SERVICE BULLETIN

L1025 2026-02-25

L1025: PRODUCT PROGRAM 1902 S2 ABS/EHCU MODULE CORRECTION

Figure 1. Not Configured

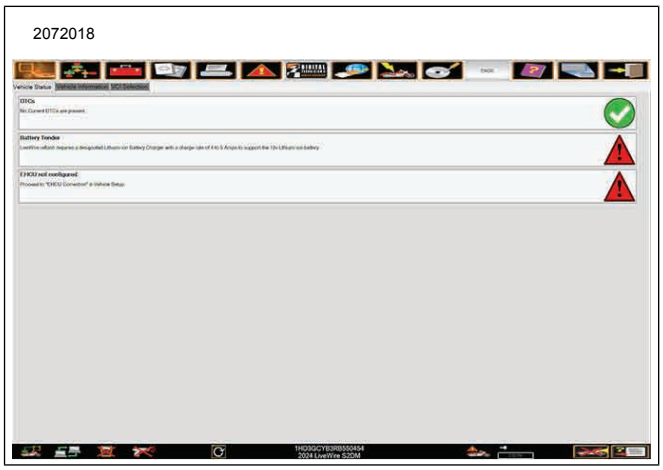
2. Connect DT II to the vehicle. The Vehicle Status screen will display that the EHCU is not configured. See Figure 1.

3. **Navigate:** Toolbox > Vehicle Setup.

a. Select ABS EHCU Correction.

b. Follow on screen instructions.
